Oyster Creek License Renewal Project Drywell Monitoring Program

Information for ACRS Subcommittee

Subject: Response to NRC Request for Additional Information, dated March 10, 2006,
Related to Oyster Creek Generating Station License Renewal Application (TAC
No. MC7624)

**Response to 3/10/06 Request for Additional Information
Oyster Creek Generating Station
License Renewal Application (TAC No. MC7624)**

Fig. – 3 Corrosion Trend in Sand Bed Region Bay with highest Drywell Shell Wall Thinning

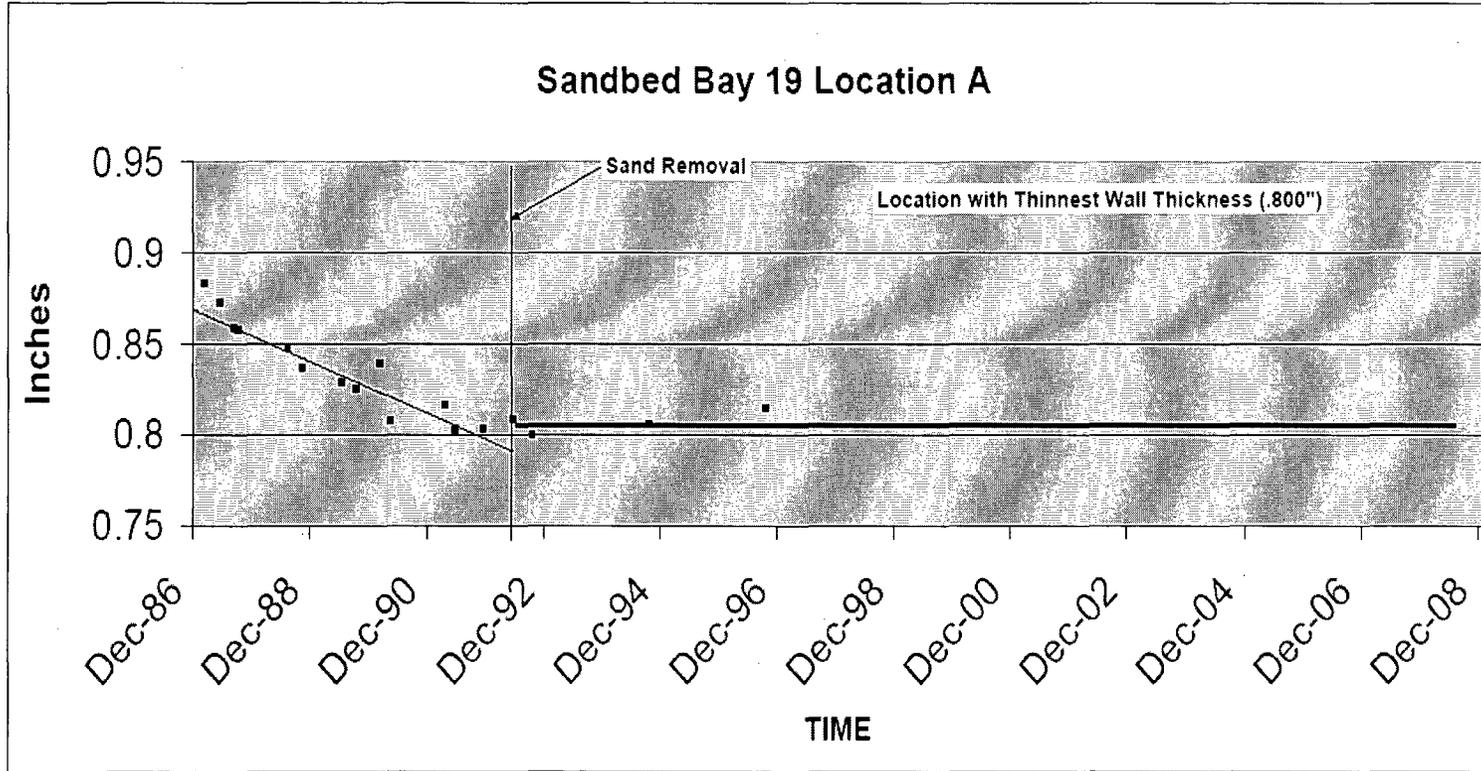
- (a) For the drywell corrosion existing during the late 1980s, and the new corrosion found during the subsequent inspections, provide the process used to establish confidence that the sampling done and the areas considered for identifying the areas of corrosion have been adequate.
- (b) Provide a summary of the factors considered in establishing the minimum required drywell thicknesses at various elevations of the drywell.
- (c) LRA Reference 4.8-21 discusses pros and cons of various methods of mitigating the drywell shell corrosion. Provide a summary of the actual mitigating actions taken and their effectiveness.
- (d) Provide a comparative graph (or chart) showing the drywell thickness based on the assumed corrosion rate and that actually found after the mitigating actions were implemented.

Based on the discussion above and as indicated in the tables supplied in response to item d) below, Oyster Creek concluded that drywell corrosion is effectively managed both during the current and proposed renewed terms of plant operation. The monitored locations under the current term were subject to extensive UT measurements conducted over several years. NRC Staff found the sampling methodology to identify these locations, and the results of inspections, acceptable for the current term. The same locations will be inspected during the extended period of operation.

Figure 2 - Drywell to Reactor Cavity Seal Detail

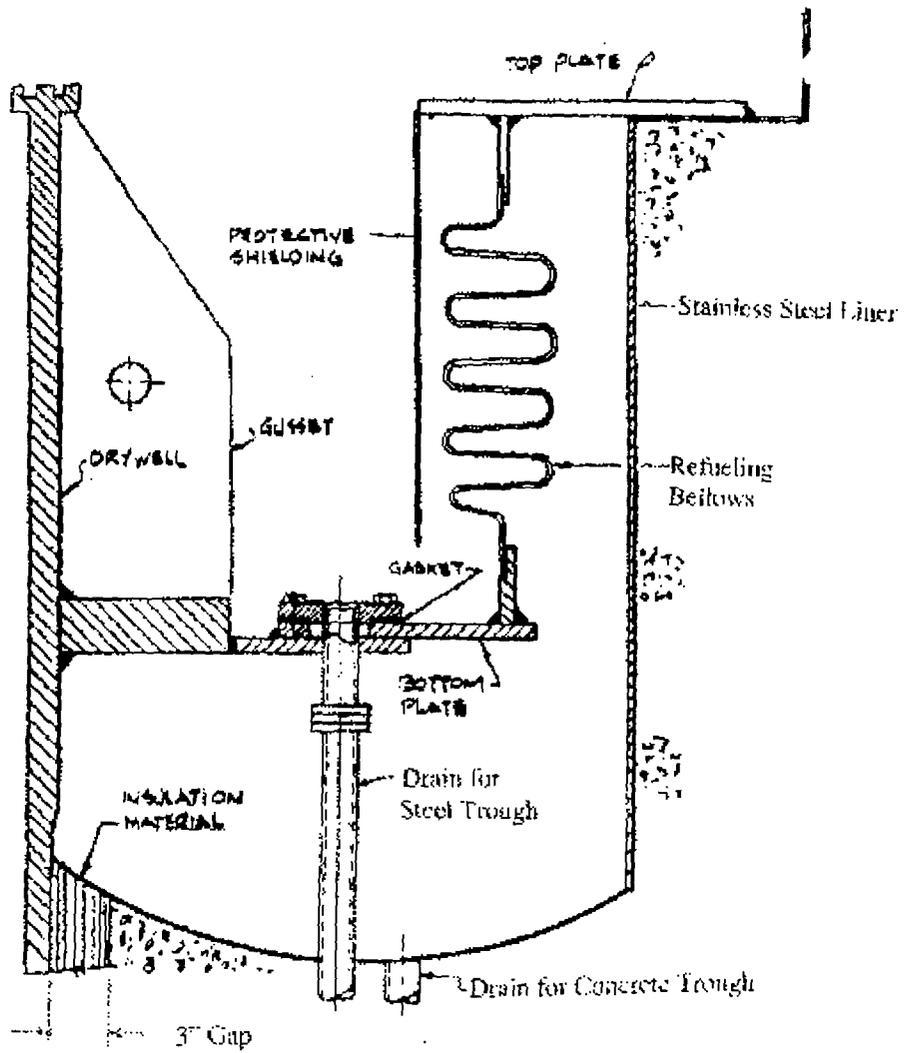
Leakage from the refueling seal has been identified as one of the reasons for accumulation of water and contamination of the sand-pocket area. The refueling water passes through the gap between the shield concrete and the drywell shell in the long length of inaccessible areas. As there is a potential for corrosion in this area, Subsection IWE of the ASME code would require augmented inspection of this area. The applicant is requested to provide a summary of inspections performed (visual and NDE) and mitigating actions taken to prevent water leaks from the refueling seal components.

Oyster Creek is currently committed to monitor the sand bed region drains for water leakage. A review of plant documentation did not provide objective evidence that the commitment has been implemented since 1998. Issue Report #348545 was issued in accordance with Oyster Creek corrective action process to document the lapse in implementing the commitment and to reinforce strict compliance with commitment implementation in the future, including during the period of extended operation.
